Written Submission

Public Utilities Board

Muskrat Falls and Labrador/Island Transmission Link

Hydro Electric Project

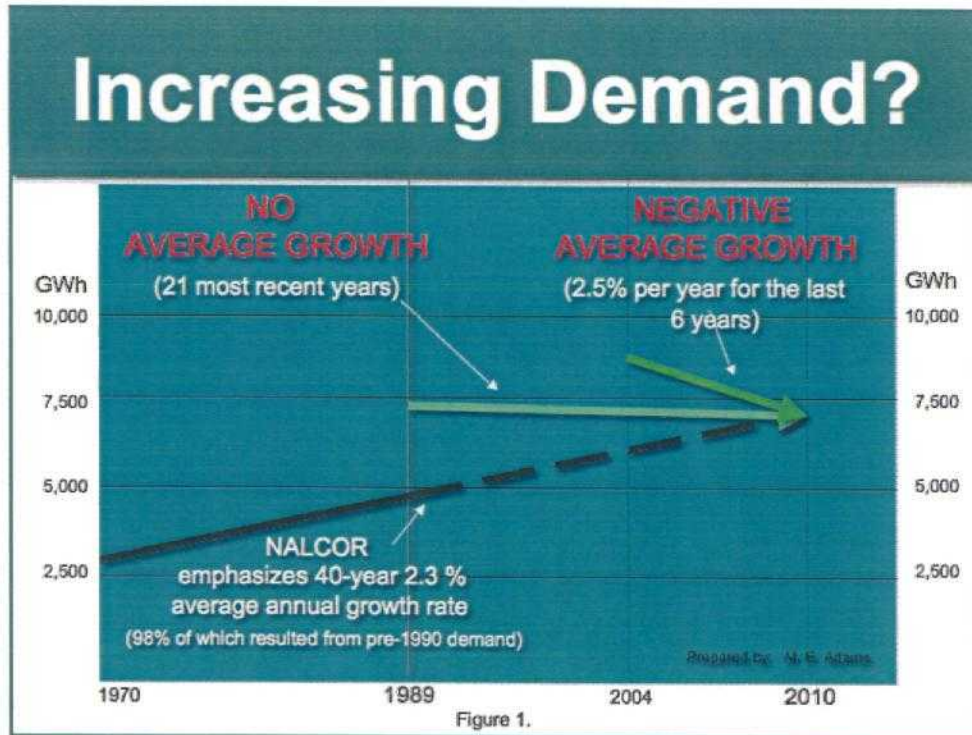
About 98% of that 40-year average annual growth rate of 2.3% resulted from pre-1990 demand. Clearly there has been virtually no average growth over the more recent and **more relevant** 21-year period, and furthermore, there has been on average an annual **negative growth** rate of 2.5% over the most recent and most relevant 6-year period.

So, is a 0.8% forecast average compound annual growth rate for the next 57 years really, as Nalcor claims, “conservative”, when 0.8% is 8 times more than the 0.1% average growth rate that the island has actually experienced over the most recent and most relevant 20-year period? See Figure 1 (below).

Figure 2.
Systemic Forecasting Error

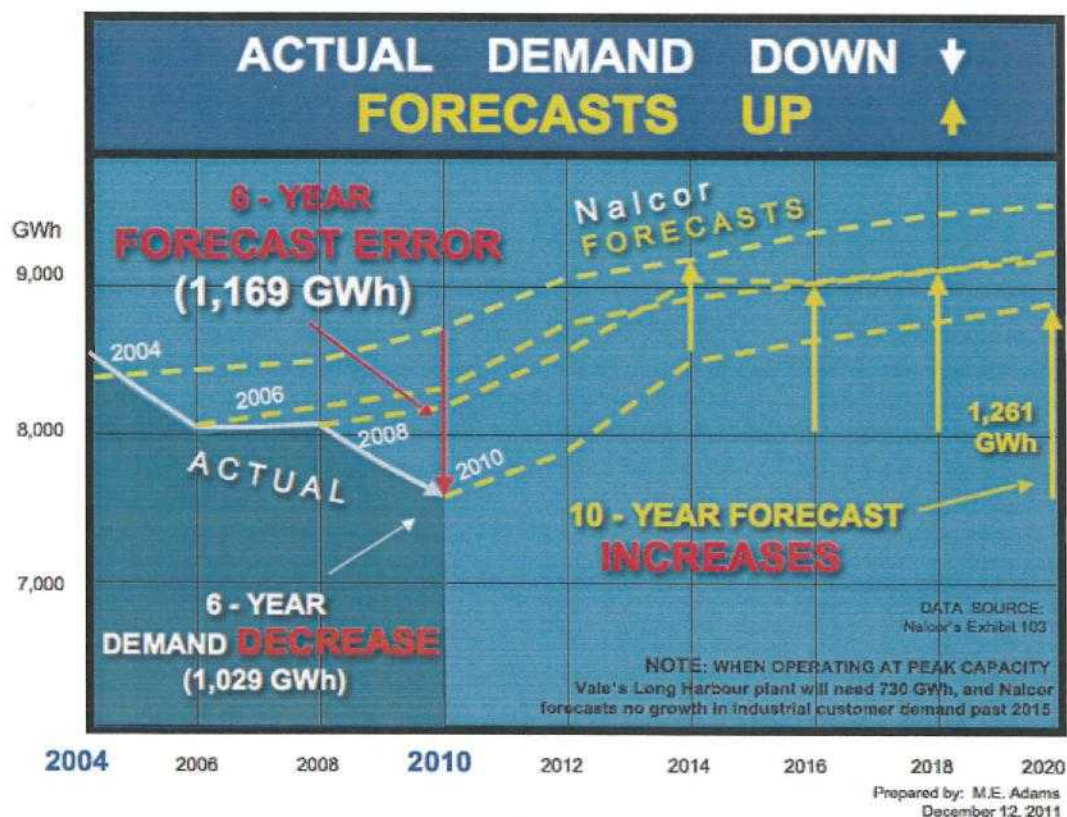
Furthermore, as Figure 2 (below) demonstrates, Nalcor's demonstrated track record for over-forecasting the island's total energy demand appears to have been systemic.

While total island load kept going down, year over year, Nalcor's forecast kept going UP, year over year.

(Figure 2 shows systemic error in Nalcor's/NL Hydro's forecasting. Over a 6-year period demand moved consistently DOWNWARD, while forecasts moved consistently UPWARD. **Note:** Vale's energy forecast has since been downgraded to 640 GWh. Also, only forecasts for every second year are shown for the sake of clarity)

Figure 3.

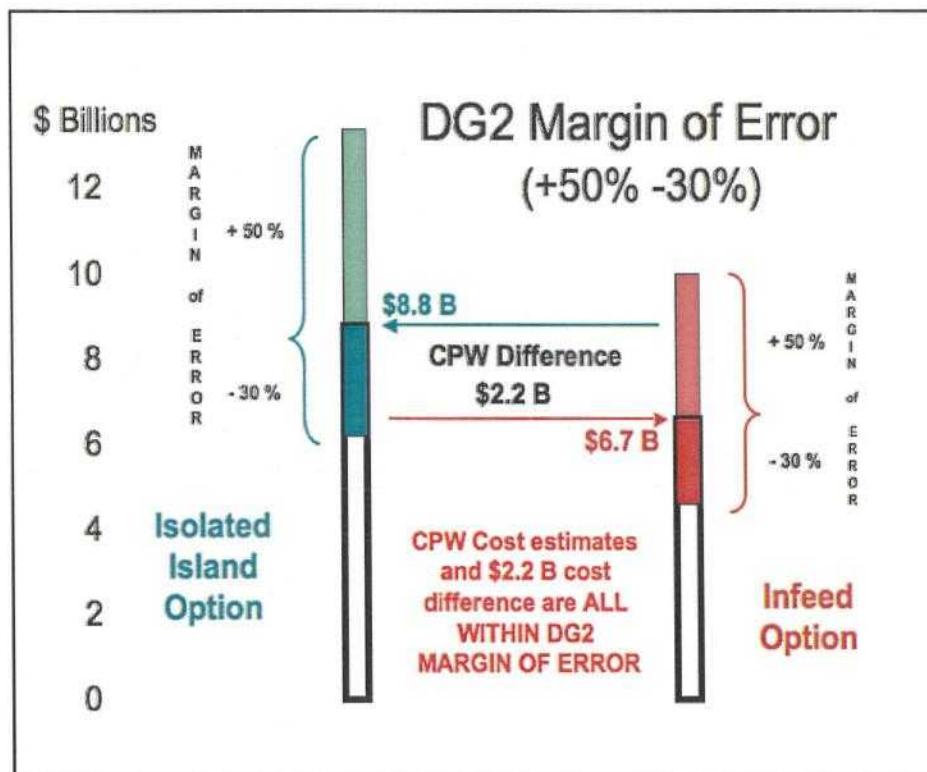
Since each DG2-quality cost estimate is **well within the industry margin of error (+50% or -30%) of the other**, it is submitted that the DG2-quality cost estimates are both 'statistically tied'. Figure 3 (below) refers.

[CPW DG2-quality cost estimates in relation to each other (and the difference between them) are within the DG2 margin of error]

Given therefore that the DG2-quality cost estimates that are before the Board (as well as the CPW cost difference of \$2.2. billion) are within each other's DG2 margins of error of +50% or -30%, and given that it is on the basis of this cost relationship (relative merit) that the Board is asked to base an analysis and to report "whether" the Infeed Option represents least cost "as compared to" the Isolated Island Option, it is respectfully submitted that these DG2-quality, Class 4, feasibility level estimates are in a "statistical (margin of error) tie" and therefore they provide **no prudent, rational and reliable**
